Question 02.05.01-46

In CCNPP Unit 3 FSAR Section 2.5.1.1.4.4.4.2, Brandywine Fault System, the text states (p.2.5-47): "The mapped trace of the Brandywine fault system coincides with the western margin of the Taylorsville basin (Mixon, 1977) (Hansen, 1986) (Wilson, 1990). This observation lead Mixon and Newell (Mixon, 1977) to speculate the origin of the Brandywine fault system may be related to the reversal of a pre-existing zone of crustal weakness (i.e., Taylorsville Basin border fault)."

Question 02.05.01-48 Figure 1 – Geologic Map by Pazzaglia (1993b)

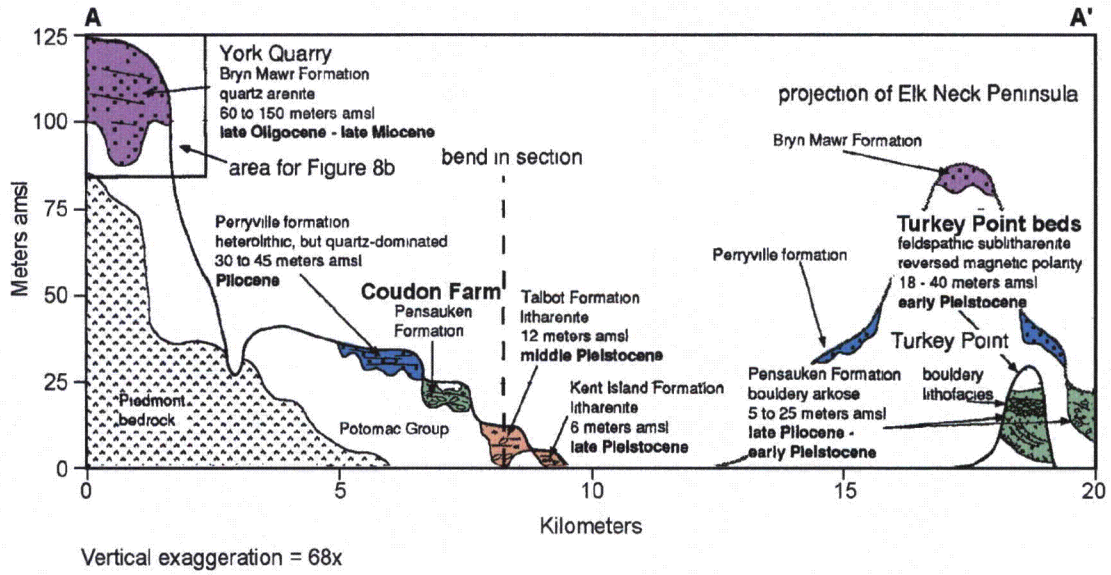
- a. Pazzaglia's interpretation of a fault (FSAR Figure 2.5-25) is based on declared vertical elevation differences of the early Pleistocene Turkey Point beds between the Coudon Farm terrace, and the Turkey Point, Grove Point, and Betterton localities in Cecil County (Figure 1). Specifically:

The early Pleistocene Turkey Point beds unconformably overlie the Pliocene Pensauken Formation (Pazzaglia, 2006). Central to Pazzaglia's interpretation of a fault is the argument that the Turkey Point beds at Coudon Farm terrace correlate with, and are equivalent to, the Turkey Point beds at Turkey Point State Park (TPSP), 10 km distant to the east (Figures 1 and 2). The fault interpretation relies on the argument that the depositional base of Turkey Point beds should lie at very similar elevations over the lateral distances in the map area, or at least dip gently eastward (Figure 2).

Question 02.05.01-49 Figure 1 – LiDAR-Based Slope Map

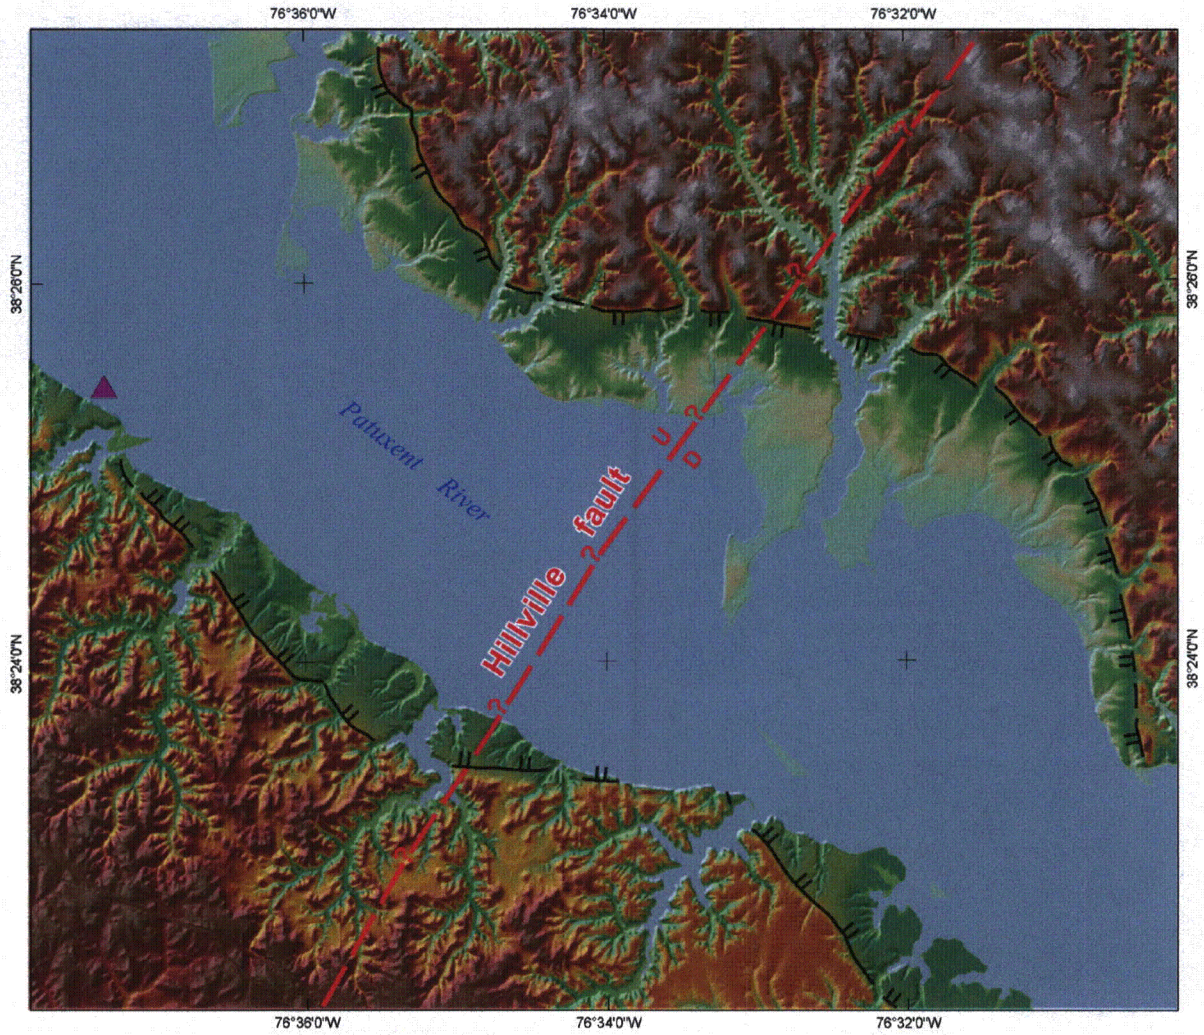
- a. Please explain how McCartan justifies the monocline on the west shore of the Patuxent river.
- b. In the same FSAR section, the text states, "Field and aerial reconnaissance, coupled with interpretation of aerial photography and LiDAR [Light Detection and Ranging] data (see Section 2.5.3.1 for additional information regarding the general methodology), conducted during this COL study, shows that there are no geomorphic features indicative of folding directly along the western shores of Chesapeake Bay." The LiDAR data presented in the FSAR, Figure 2.5-26, is at the wrong scale to examine the features discussed in this section. Please provide a LiDAR figure at a larger scale to see details of topography and post McCartans monoclines, Pazzaglia's faults, and Hansen's Hillville fault on the LiDAR.

- b. The attached Figures 1, 2, and 3 are LiDAR elevation maps at larger scales compared to FSAR Figure 2.5-26. As requested, the figures show additional detail of topography. Figure 1 is presented at approximately 1:155,000-scale, and shows McCartan's (1995) hypothesized monoclines and Hansen's (1986) Hillville fault. The monocline axes are not shown on the map by McCartan (1995); however their map-surface locations from cross-sections are indicated with a triangle symbol on Figure 1. The unnamed fault of Pazzaglia (1993) is located some 70 miles (113 km) from the site and it is not practical to include it with the other features at the requested larger scale. A LiDAR map showing Pazzaglia's unnamed fault is presented on a figure in response to RAI 130, Question 02.05.01-48.

Question 02.05.01-50 Figure 1 – LiDAR Based Slope Map

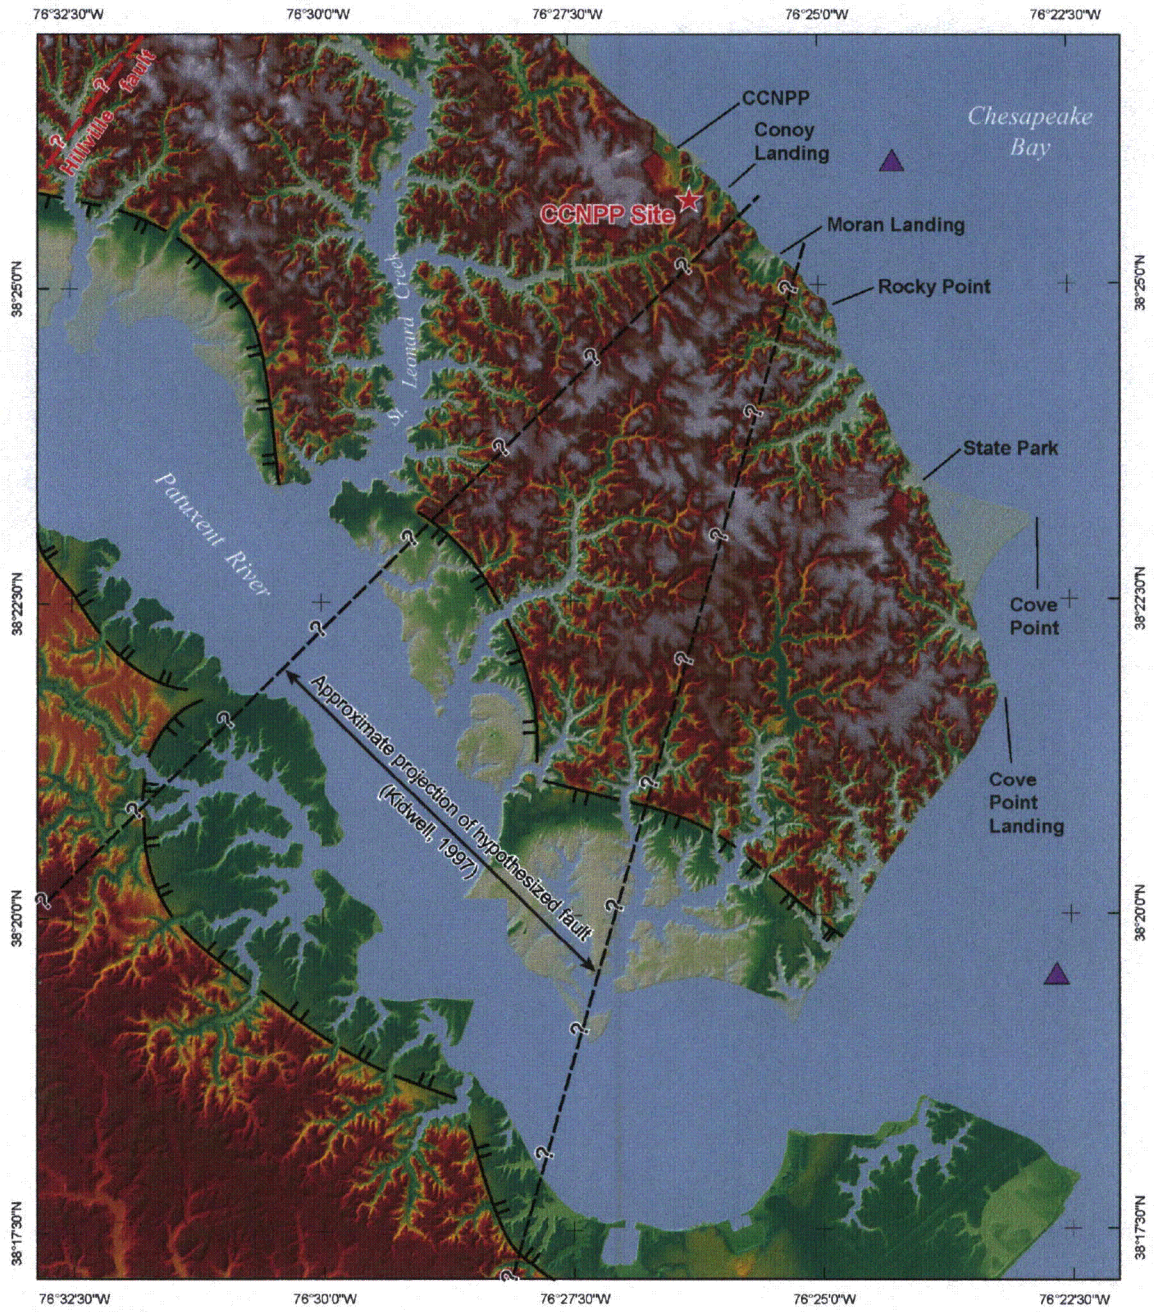
- b. In the same FSAR section, the text states, "Field and aerial reconnaissance, coupled with interpretation of aerial photography and LIDAR [Light Detection and Ranging] data (see Section 2.5.3.1 for additional information regarding the general methodology), conducted during the CCNPP Unit 3 investigation shows that there are no geomorphic features indicative of potential Quaternary activity developed in the Pliocene-Quaternary surfaces along a southeast projection from Chesapeake Bay across the Patuxent and Potomac Rivers (Figure 2.5-26)." Please provide a legible, enlarged version of Figure 2.5-26 so that the specific geomorphic features associated with Pliocene-Quaternary surfaces can be examined.

- b. As requested by the NRC staff, the attached Figures 1 and 2 are LiDAR elevation maps at larger scales compared to FSAR Figure 2.5-26. These figures show additional detail of the topography along the Patuxent River and southern Calvert County. Both figures show McCartan's (1995) hypothesized monoclines, Hansen's (1986) Hillville fault, and the location of landmarks used for geographic reference by Kidwell (1997) (FSAR Figures 2.5-26 and 2.5-30).

These topographic and geomorphic observations along the Patuxent River (Figure 1) argue for the absence of recent tectonic movement on the hypothesized fault by Kidwell (1997).

Question 02.05.01-51 Figure 10 – Aerial photograph, satellite image, and geologic map of the Everona fault exposure site, 1982 to 2006.

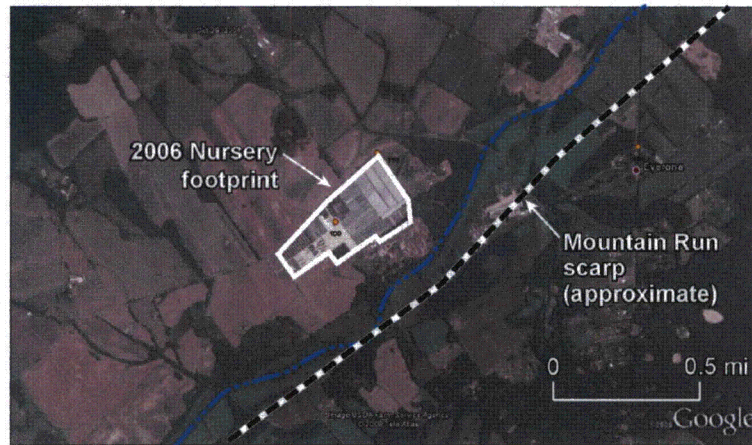
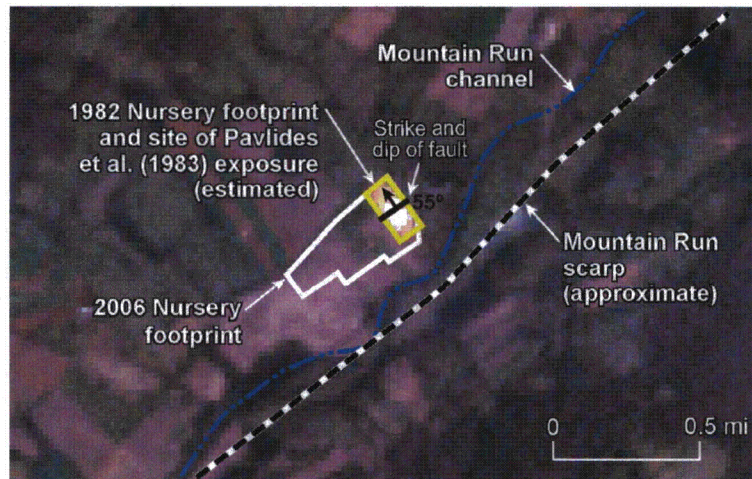
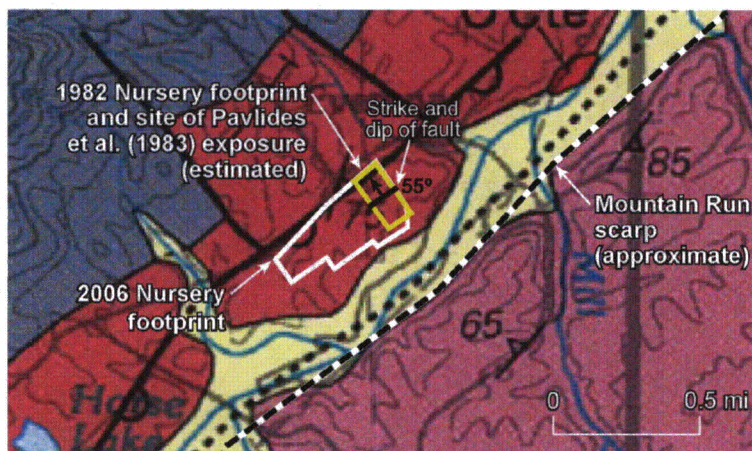
- c. In FSAR Section 2.5.1.1.4.4.5.2, Everona-Mountain Run Fault Zone, the text states, "The Mountain Run fault zone is located along the eastern margin of the Culpeper Basin and lies approximately 71 mi (114 km) southwest of the site (Figure 2.5-17 and Figure 2.5-31)." Figures 2.5-17 shows the Everona-Mountain run fault zone in relation to the Blue Ridge province and the Potomac melange but does not show relationship to the Culpeper Basin. Figure 2.5-31 shows the fault as a triangle adjacent to the Fall Lines of Weems. Please provide a figure to adequately illustrate the position of this fault in relation to the Culpeper Basin as discussed in this section at an appropriate scale to support the text.

Figure 10 shows the site of the Everona fault exposure in a series of three panels in an attempt to document the location of the exposure as precisely as possible and understand its location relative to the Mountain Run fault zone and Mountain Run scarp. Panel A) shows an aerial photo view of the Everona area and the nursery footprint near the time of the field visit (October 29, 2006 aerial photograph). The image in panel A) also shows the approximate channel of Mountain Run and the approximate location of the Mountain Run scarp according to Pavlides (1994) and Mixon et al. (2000). Small numbered orange dots in the image represent GPS waypoints collected during the field reconnaissance. Panel B) shows the same area in a November 25, 1982 Landsat™ multispectral satellite image. The low-resolution Landsat™ image shows a rectangular area with very bright reflectance relative to the surrounding cultivated areas that corresponds to the eastern end of the modern facility. The bright rectangle is interpreted to represent the site of the nursery in late 1982, which may include existing facilities and/or areas excavated for the nursery. The area of this high-reflectance rectangle probably includes the Everona fault exposure documented by Pavlides et al. (1983). In panel B), a symbol is approximately located for a fault exposure with a N55°E strike and 55°NW dip (this orientation follows the description of Crone and Wheeler (2000)). Panel B) also shows the approximate locations of the Mountain Run channel and the Mountain Run scarp of Pavlides (1994) and Mixon et al., (2000).

Panel C) of Figure 10 shows the portion of the Mixon et al. (2000) geologic map that coincides with the image extent in panels A) and B). Figure 11 shows a portion of the map explanation from Mixon et al. (2000) for interpreting map units and symbols. The map in panel C) shows the approximate location and extent of the nursery footprints circa 1982 and 2006, and shows the approximate location and orientation of the fault exposure as in Panel B). The map clearly shows that the exposure is located within or near the northwest margin of the Mountain Run fault zone as mapped by Mixon et al. (2000), and that the fault exposure is inferred to be located within the True Blue formation that is affiliated with the Blue Ridge province. The dotted line within the alluvium-filled valley of Mountain Run presumably coincides with a concealed fault boundary that separates the True Blue formation to the northwest and the mélange of the Mine Run Complex (Piedmont province) to the southeast. From the descriptions of Pavlides (1994) and Pavlides (2000), the Mountain Run scarp is plotted to coincide with the southeast margin of the Quaternary alluvium within the Mountain Run. Figure 10 shows the Everona fault to be about 0.4 miles (about 2000 feet) northwest of the Mountain Run scarp.

Question 02.05.01-53 Figure 1 – Central Virginia Seismic Zone illustrating seismicity, principal faults, liquefaction site and the I-64 seismic line

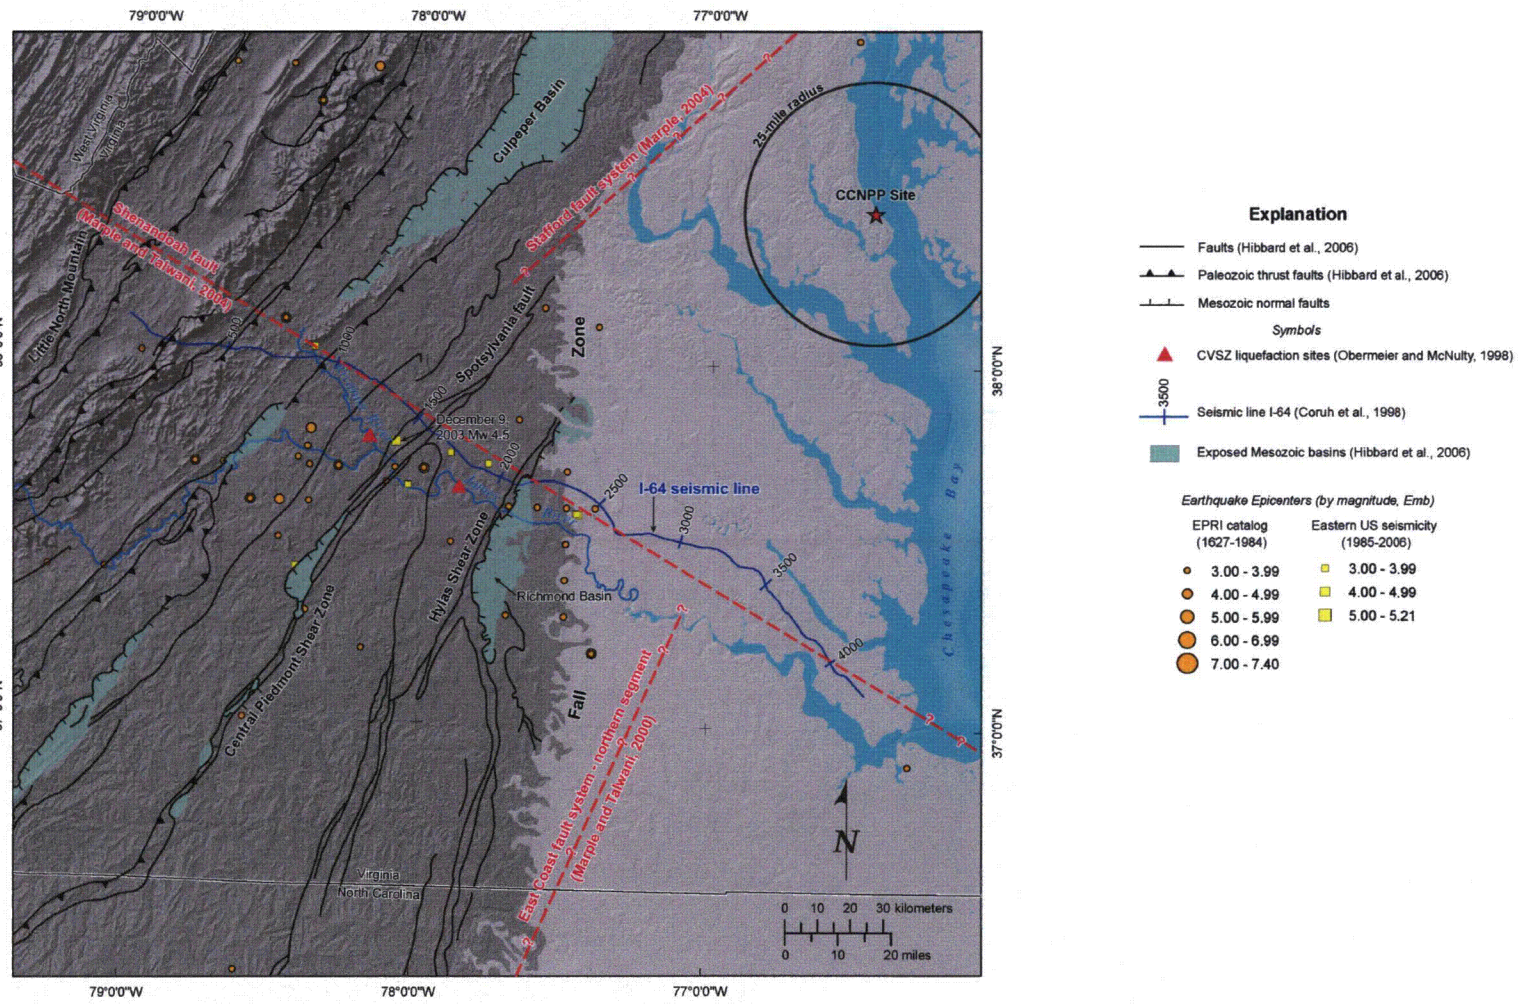
- b. In the above RAI question part b, the NRC staff has requested several additional illustrations to provide further documentation of concepts discussed in the FSAR text regarding the Central Virginia Seismic Zone (CVSZ) (Figure 2.5-51). Figure 1 contains much of the above requested information and includes: 1) pre- and post-1986 seismicity, 2) Spotsylvania fault (Hibbard et al., 2006), 3) paleoliquefaction sites of Obermeier and McNulty (1998), and 4) the hypothesized Shenandoah fault (Marple and Talwani, 2004) and Norfolk fracture zone. Figure 2 is a reproduction from Coruh et al. (1988) who discuss the diabase dike swarm and Figure 3 illustrates the Shenandoah fault and the Norfolk fracture from Marple and Talwani (2004). Below is a description of these figures to help clarify the discussion in the FSAR text regarding the CVSZ (Figures 1-3).

As discussed in FSAR Section 2.5.1.1.4.5.1, Coruh et al. (1988) made correlations between earthquake hypocenters and potential seismogenic structures imaged in the I-64 seismic reflection profile. The location of the I-64 profile is shown on Figure 1 and the automatic line drawing display of the seismic reflection data is shown on Figure 2. Coruh et al. (1988) projected 26 hypocenters with an approximate vertical error of less than 5 km onto the seismic data (Figure 2). Using Figure 2, Coruh et al. (1988) correlate two zones of seismicity and with two geologic structures. In one case, a zone of west-dipping hypocenters coincides with a series of west-dipping reflectors along the western flank of a roof antiform between Stations 1300 and 1700 (marked by 'B') (Figures 1 and 2). In the second correlation, a zone of weak seismic reflectors, interpreted as a Mesozoic diabase dike swarm, is coincident with a diffuse pattern of seismicity between stations 2050 and 2250. This zone of diffuse seismicity (marked by 'D') contains five hypocenters and appears to continue across the deeper Moho reflectors. On the basis of the seismicity and seismic reflection data, Coruh et al. (1988) argue for the presence of two different seismogenic structures (e.g., a fold and a dike swarm), rather than a single seismic source within the CVSZ. They continue that "the earthquake activity in central Virginia seismic zone may be detachment-related only on the west flank of the roof of the antiform" p.750 (Coruh et al., 1988).
